**REQUEST FOR BID 2860-05A, 2860-05B, 2860-05C, 2860-05D
W 76 Country Blvd Streetscape – Segments 1 and 2**

Addendum No. 1

Addendum NO 1

FOR: W 76 Country Boulevard Streetscape Improvements,
Contracts EN7622, SNS0032 &
W 76 Country Blvd Median Improvements
Contracts TAP-9901(886) and STP-0761(023)
GRE Project 4515

3. Change to 3-Way Isolation Valve Detail – Sht W13

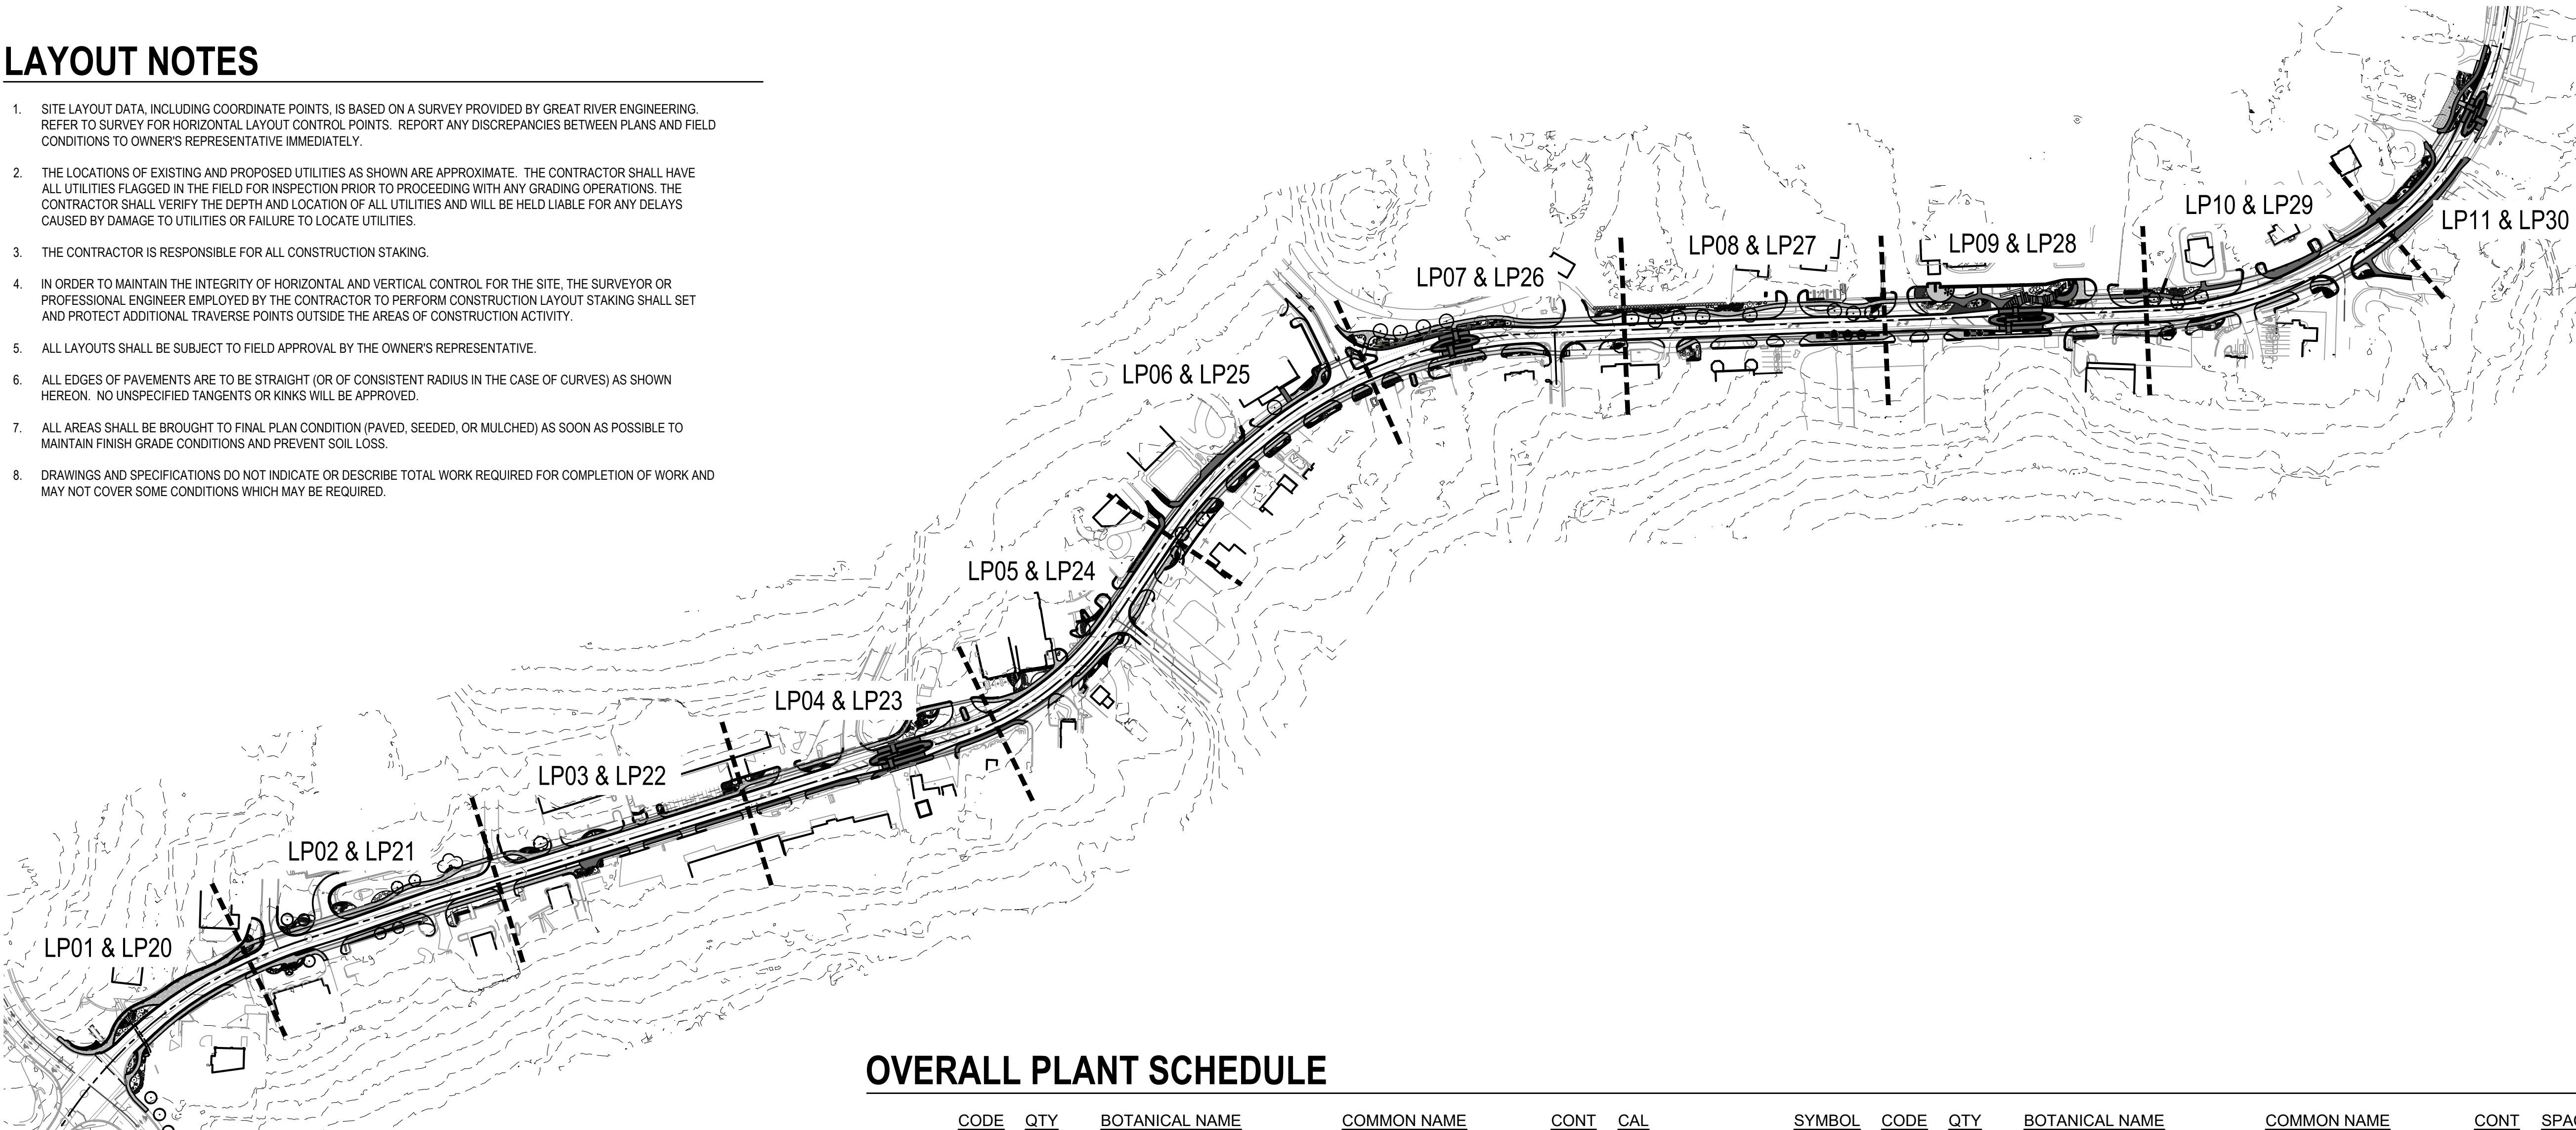
See revised detail below:

DATE: 06/16/2026
JOB NUMBER: 4515
SHEET
EX01 OF 13

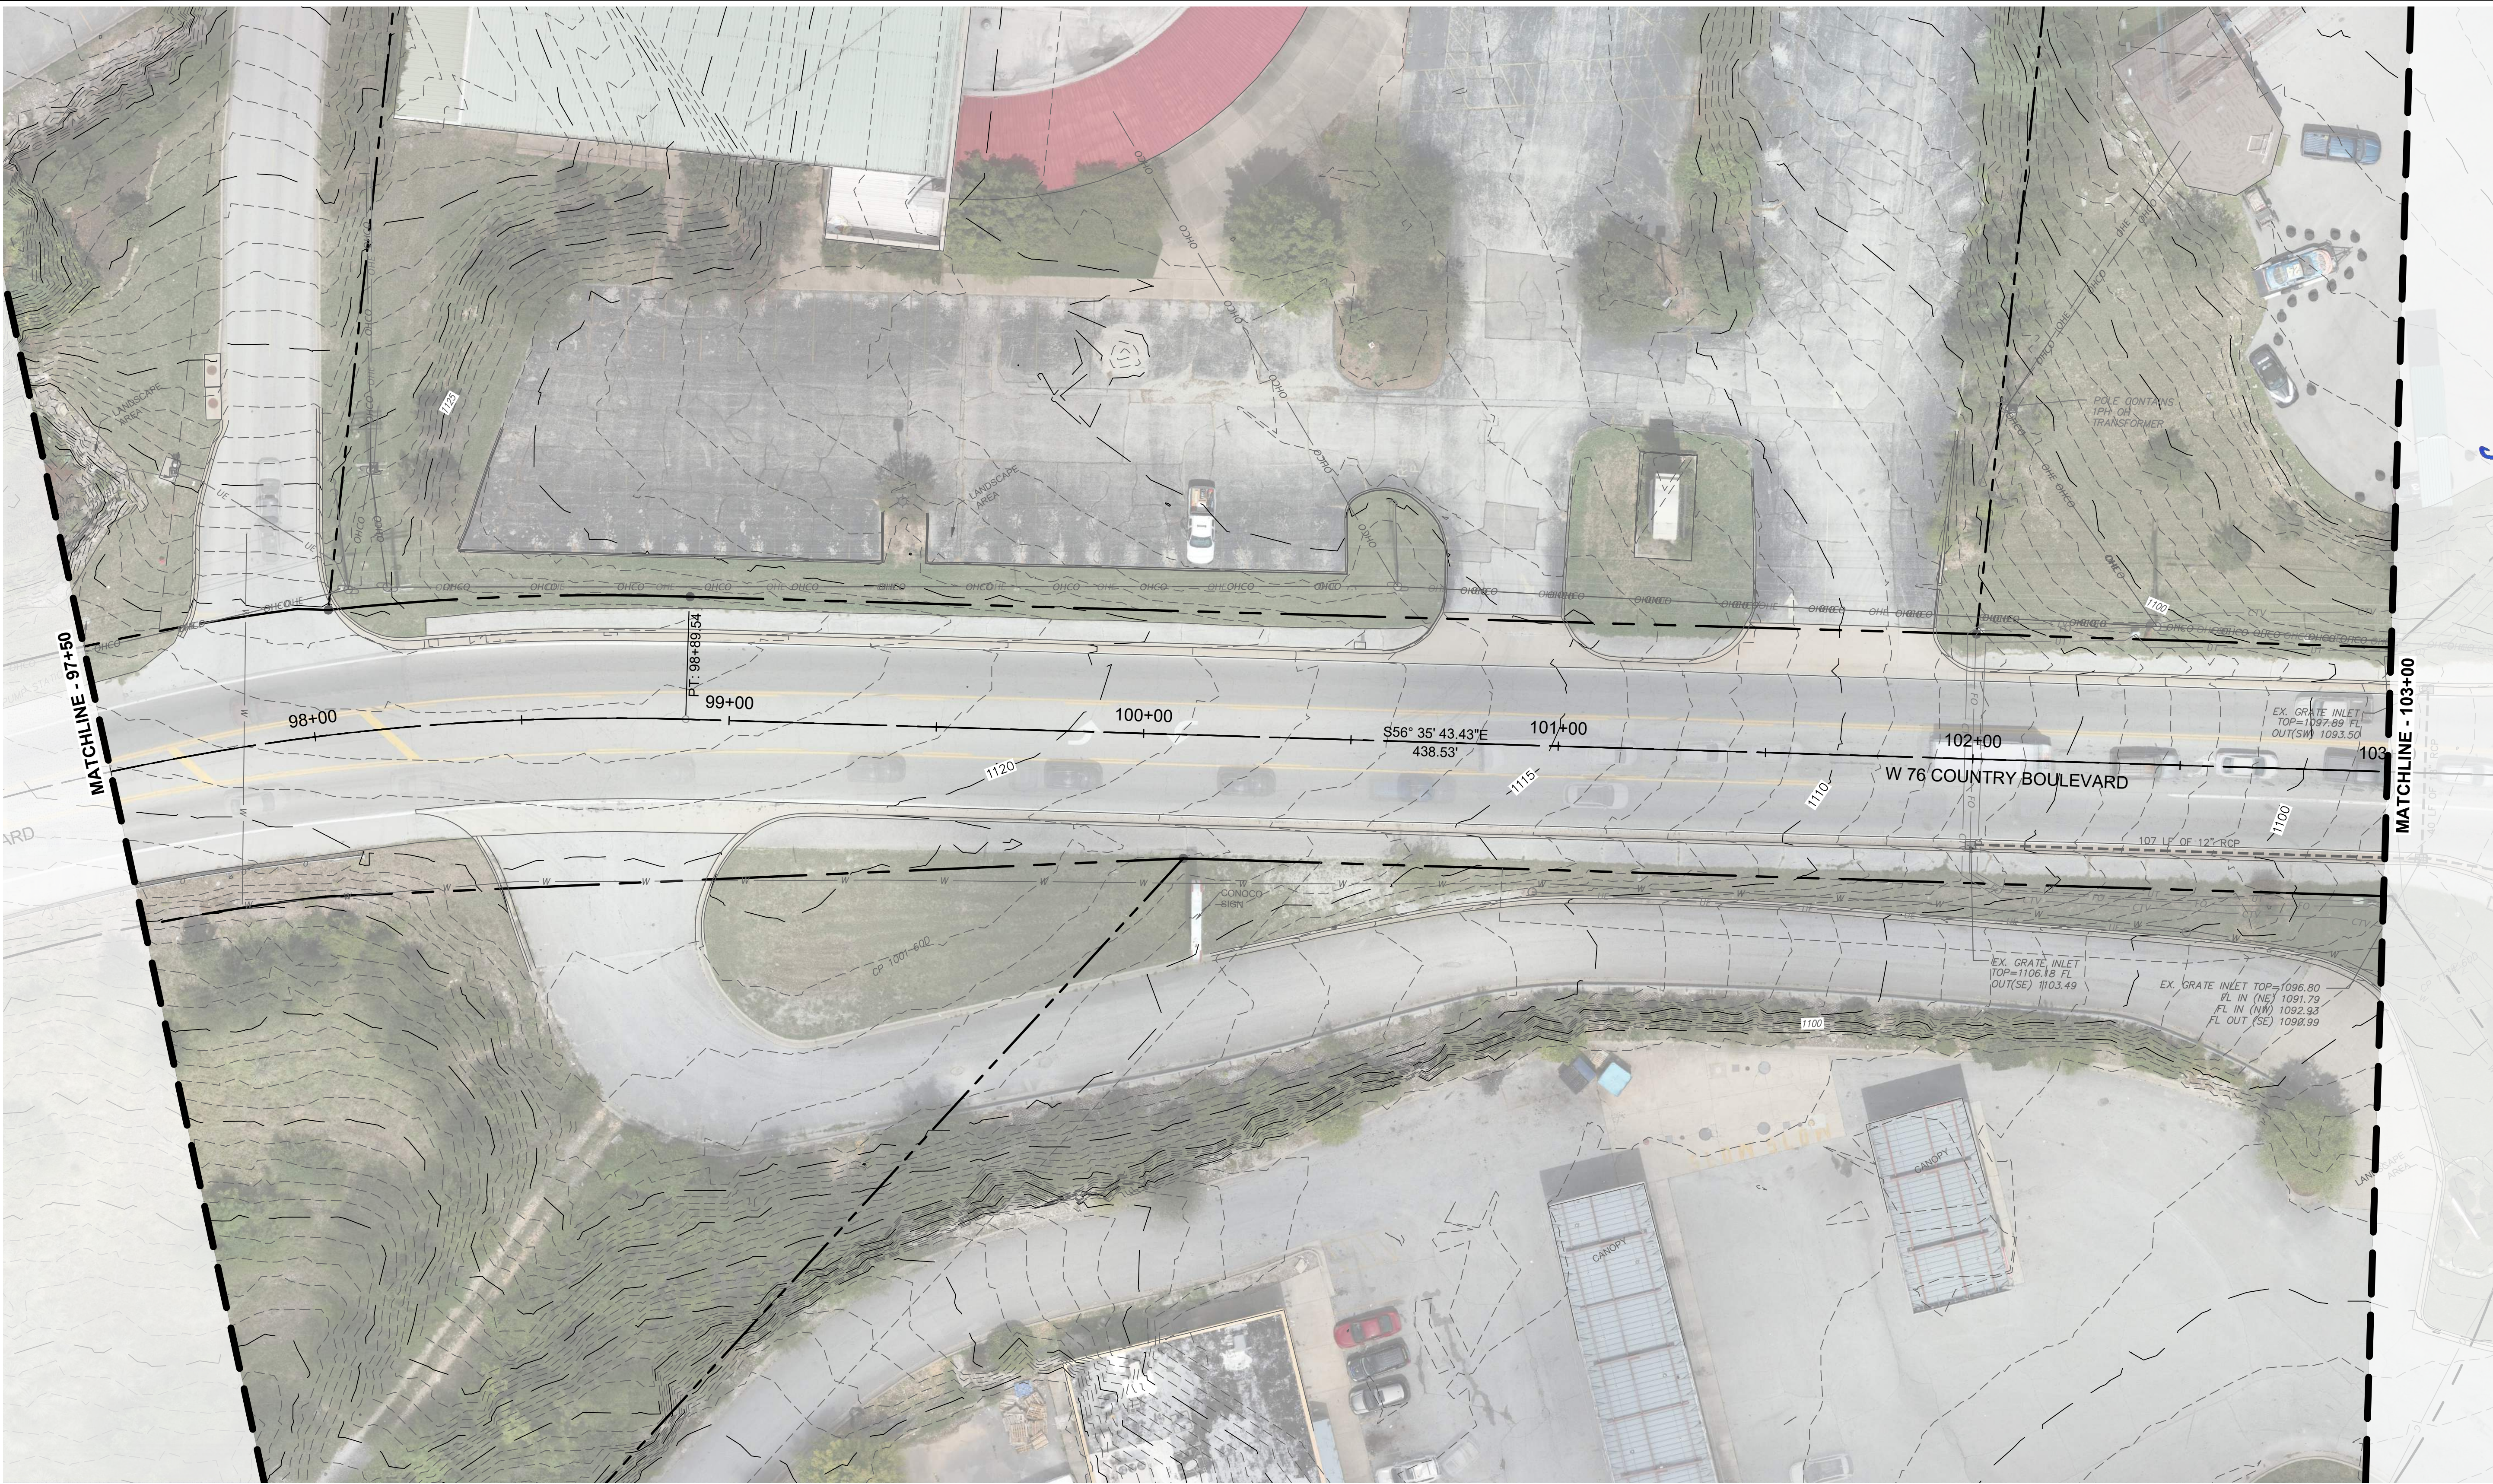
2. Changes to Existing Conditions Plan sheets – The existing conditions sheets included with the original set of plans did not have existing poles identified.

See attached Amended Existing Conditions Plan sheets showing existing poles. Sheets EX 1 thru EX 13

No.	Revision/Issue	Date
1	SHOW UTILITY POLES
